**From:** Neil Duffield  
**Sent:** 18 July 2011 17:04  
**To:** Hilary Saunders  
**Cc:** 'Emily Thwaite'; 'Bill Sanderson'  
**Subject:** Grosmont School(E9922-39 NYMNP 18\_07\_11)

Project  
**Alterations to  
 Old School House Grosmont**

Package  
**Proposed  
 Elevations  
 and Roof Plan**

Drawing No  
**D9922-04**

**Roof Plan**  
 1:100

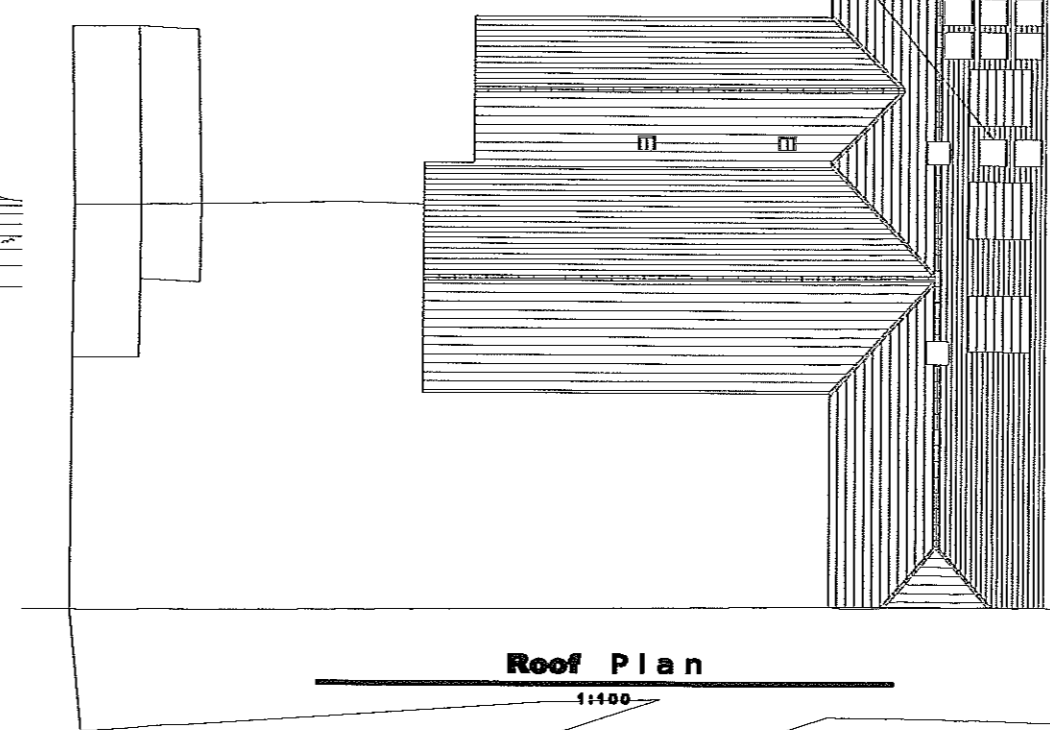
In respect of our conversation regarding the solar panels I attach a revised drawing showing all panels to the East end of the roof. The actual Engineers design requires 3 Solar Thermal and 10 Solar PV panel, ie 3 fewer than our original illustration.

G	18/06/11	EH	Amended solar panels
F	14/06/11	DC	Air source heat pump shown
E	11/06/11	DC	Kitchen window position altered
D	22/12/10	MD	Added ground source location
C	18/12/10	MDP	Rear Panel layout
B	09/11/10	MDP	Amended to suit client
A	04/11/10	MDP	Issued for approval
